**FROM:** Jerry Hauck, jerry\_hauck@ccm.sc.intel.com  
**TO:** P1394a Working Group  
**DATE:** October 8, 1997  
**RE:** Isochronous period too long

Subclause 9.20 of the P1394a Draft 1.1 states:

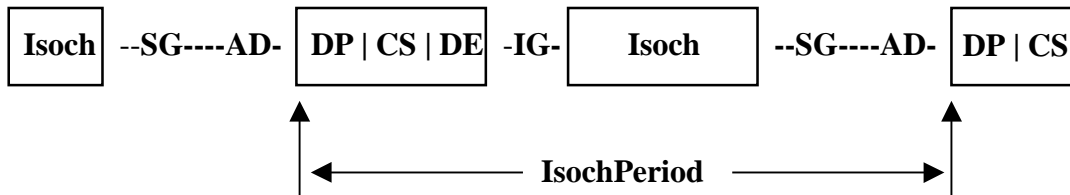
Consider the following limiting model of bus behavior:

Note: For this example, I've defined the IsochPeriod to include the Arb delay which follows a subaction gap.

Consider three possible durations for the IsochPeriod described above:

- i. **IsochPeriod > 125  $\mu$ s:** This is a trivial case ... after a finite number of back to back isoch intervals, there will be at least one interval during which two

cycleSync's occur within the same period. Consequently, cycles are lost because the bandwidth is over subscribed. No asynch packets (other than cycle start) are ever sent.

- ii. **IsochPeriod = 125  $\mu$ s:** This is the boundary case. Whatever phasing the cycleSync interval has with the cycle start packet will remain constant over all cycle start packets. There is an exact one-to-one ratio of cycleSync's to IsochPeriod's. This case can repeat indefinitely without loss of isochronous data or cycles, but no asynchronous packets other than cycle start can ever be sent.

- iii. **IsochPeriod < 125  $\mu$ s:** This case guarantees that asynchronous packets can be sent with *some* frequency. This does **not** guarantee that an asynch packet can be sent each isochronous period, however. Since the cycleSync period = 125  $\mu$ s and the IsochPeriod < 125  $\mu$ s, the phasing of cycleSync's relative to the end of the isoch period will "walk". Said differently in each successive isoch interval, the next cycle sync will occur later in time relative to the end of the last isoch packet. After a finite number of back-to-back isoch periods, there will be at least one phase alignment in which the PriReq to the PHY resulting from the cycleSync occurs after the subaction\_gap + arb\_delay interval. When this occurs, the PHY will have to wait until an arb\_reset\_gap + arb\_delay interval elapses before granting the bus for a cycle start. While waiting for this arb\_reset\_gap, the PHY is guaranteed to recognize and grant any arbitration request from any node which was triggered by the subaction gap. Voila ... an asynch packet gets a chance. The number of back-to-back isoch cycles which occur before an asynchronous packet sees an opportunity becomes a function of how close the IsochPeriod is to 125  $\mu$ s.

It is my understanding that Draft 1.1 of P1394a intended to allow case ii above; i.e., isochronous transmission could continue forever without any guarantee for asynchronous delivery. To allow case ii:

$$\begin{aligned} \text{IsochPeriod} &= 125 \mu\text{s} \\ \text{DP} + \text{CS} + \text{DE} + \text{IG} + \text{Isoch} + \text{SG} + \text{AD} &= 125 \mu\text{s} \end{aligned}$$

The description in 9.20 implies that a timer (which I'll call cycleTooLongTimer) starts counting with the start of the cycle start packet and ends with the subaction gap indication. Therefore, the proper trigger point to allow case ii would be given from the above as:

$$\text{cycleTooLongTimer} + \text{AD} > 125 \mu\text{s}$$

So, it appears that the "proper" time-out should be 125  $\mu$ s – AD, not the 125  $\mu$ s limit noted in 9.20. With a gap count of 63, AD ~ 2.6  $\mu$ s, giving a time-out of ~122.4.

Adopting case iii as the only valid operating regime, the ideal P1394a trigger point would be given as:

cycleTooLongTimer  $\geq$  125  $\mu$ s – AD, or  
cycleTooLongTimer  $\geq$  122.4  $\mu$ s (with a gap count of 63)

Since the specification of a precise time-out isn't called for in this application, I suggest that a reasonable detection range be allowed for by the spec in order to ease implementation. This also allows us to be a bit sloppy with regards to the issue of PHY/LINK notification delays, precise start/stop timing definitions, etc. Consequently, I propose the following replacement text for subclause 9.20:

If the cycle master detects an isochronous period that exceeds the allotted time, it shall clear its own *cmstr* bit and cease transmission of cycle start packets. The cycle too long condition shall be detected whenever the duration of the current isochronous period, if maintained in subsequent periods, would starve transmission of asynchronous packets other than cycle starts.

To meet this requirement, implementations with a discrete PHY and a dedicated period timer should trigger no less than 115  $\mu$ s and no more than 120  $\mu$ s after sending a cycle start unless a subaction gap or bus reset indication is first observed.

Implementations without a dedicated period timer should observe the cycle\_offset fields of consecutive cycle start packets and trigger when, in the absence of intervening asynchronous traffic, a subsequent cycle\_offset either remains constant or increases relative to a previous cycle\_offset. Bus events which constitute asynchronous traffic in such an implementation include:
